Subject: Information on L3B/L2R Timing Chain Tensioner Gasket

Information

5512284

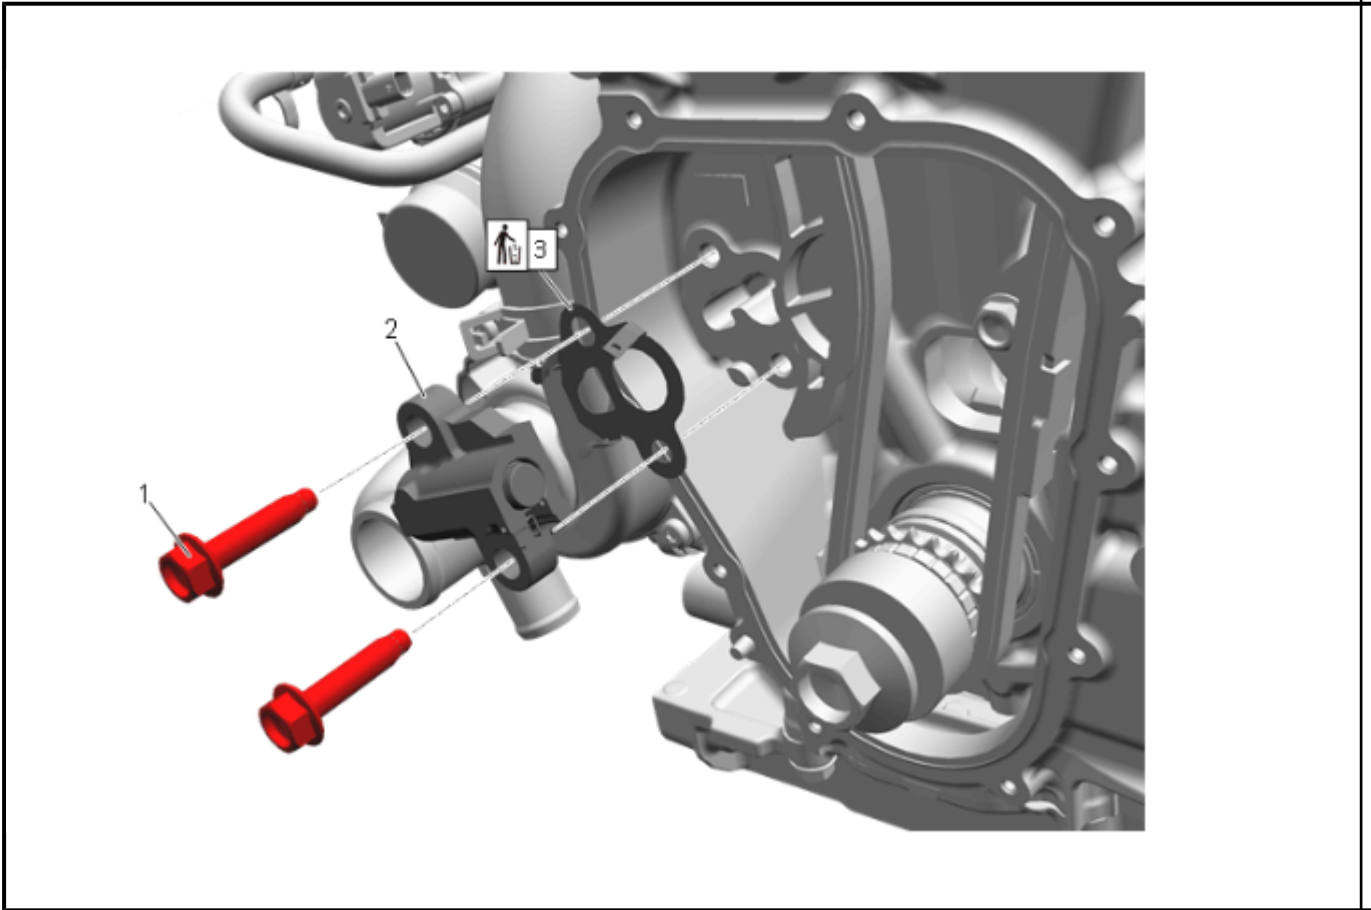
In- volved Re- gion or Coun- try	North America
Con- di- tion	Some technicians may comment on when removing the Timing Chain Tensioner, a Timing Chain Tensioner Gasket may not be present.

This is per GM design; the Timing Chain Tensioner Gasket (3) is **no longer necessary**.
